Name: Sedona Subdivision - Final Plat

**FILE #** 13-93

Title: SEDONA SUBDIVISION, FINAL PLAT

SEDONA SUBDIVISION  
FINAL PLAN REVIEW  
BY J.D.N. 2-9-93

SHEET 2  
 Located in the SE1/4 Section 30, T15, R1E, U1E M.

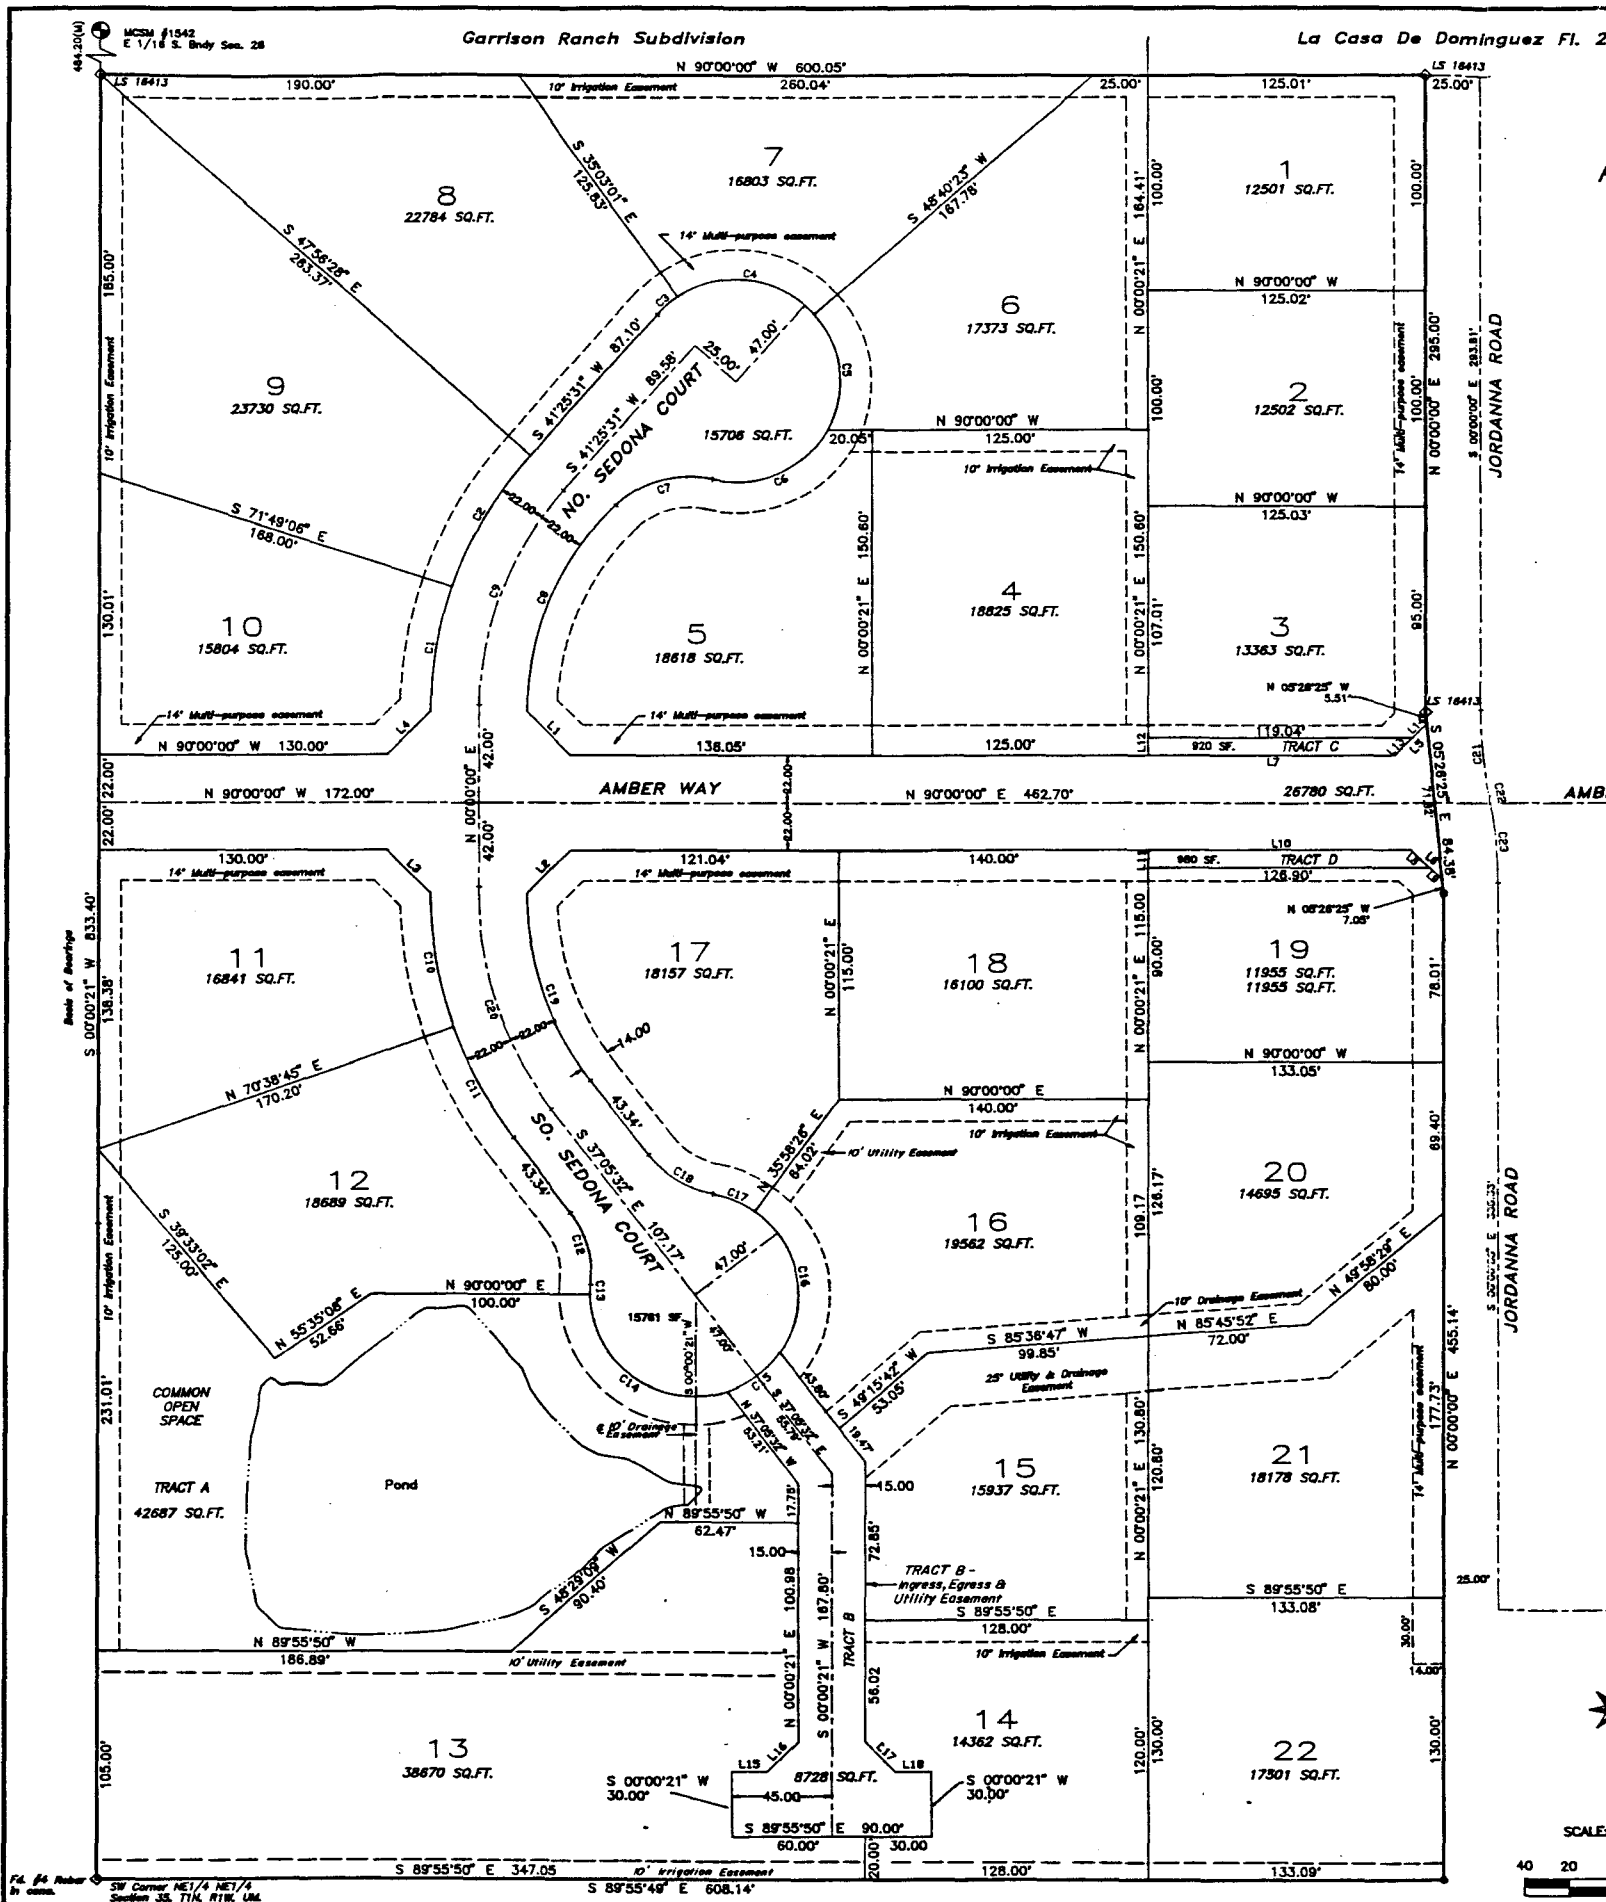
1. Please correct language in dedication on plat to conform with Zoning and Development code requirements. See attached.
2. The petitioner has requested that the ROW required at Preliminary be waived because neither he nor the property owner to the west desires it. Access to the property to the west is accomodated by an easement through another property along 7th Street. Staff does not support this request because the ROW needs to remain for future utility connections and looping and/or future road and traffic circulation.

3. What are the specific setbacks that are being proposed for this development. Please include on the final plat a table listing the setbacks. This may be accomplished instead by providing a site plan showing building envelopes for each lot which then will be recorded along with the plat.

Need additional easements (10' minimum)

1. North side of Lot 22
2. South side of Lot 15
3. East side of Lot 13
4. East side of Tract A

- (1) Grand Valley Water Users Association requests that the 10' irrigation easement shown along the south boundary of the subdivision be made a 15' wide easement to conform with that in the adjacent subdivision to the east. Grand Valley Water Users Association has a piped lateral in this easement and the extra width is needed for future operation and maintenance.

1. The Final Plat "dedication" has been modified as requested.
2. Building Setback requirements have been added to the Final Plat.
3. It is the petitioner's desire to require maintenance and landscaping of that portion of Amber Way which is not improved to be the responsibility of the lot owners on each side of the right-of-way. Doing so eliminates a third party, should the right-of-way ever be vacated in the future.
4. An Aviation Easement is attached.
5. The Improvements Guarantee was transmitted with the initial submission to the department.

Requested easements have been added to the Final Plat.

The requested increase in easement width has been added to the Final Plat.

**STREET DRAINAGE DETAILS**

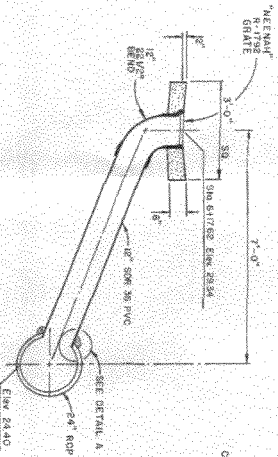
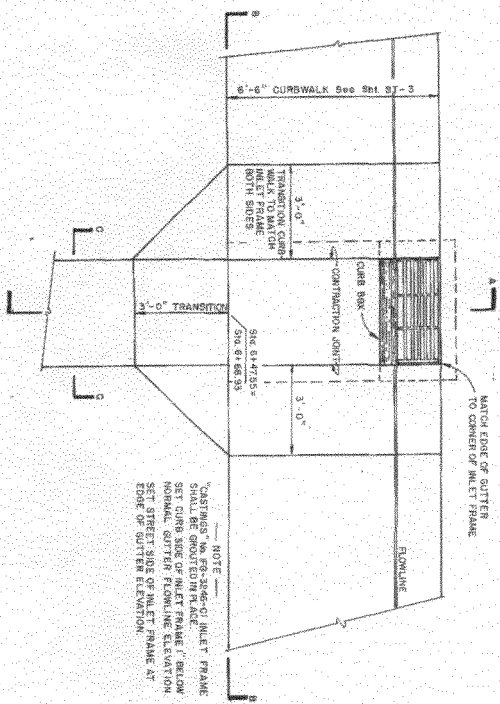
ST-4 STREET DRAINAGE DETAILS

8. Need hydraulic calculations for sizing drainage inlet on S. Sedona Ct. and drainage pan between court and drainage channel (Based on 2 year storm)
9. Need revised drainage report addressing comments made during preliminary plan review.

1. The intersection of Amber Way and Jordanna Road has been modified by elimination of cutting of the existing pavement adjacent to the cross pan and fillets.
2. Curve data has been added to the horizontal centerline curves.
3. The 30" culvert at Sta. 2+30 has been changed to "reinforced concrete pipe".
4. A driveway apron has been specified to be constructed in accordance with current City standards at the Private Drive and South Sedona Court.
5. Vertical curve lengths have been expanded to a minimum of 150 feet in length.
6. The "joint detail" has been change to reflect a 3/4 inch width.

1. Street Pavement Design Calculations.
2. Hydraulic calculations utilized in sizing various drainage structures.
3. Revised Drainage Report addressing Preliminary Plan comments.
4. Irrigation Design Report.
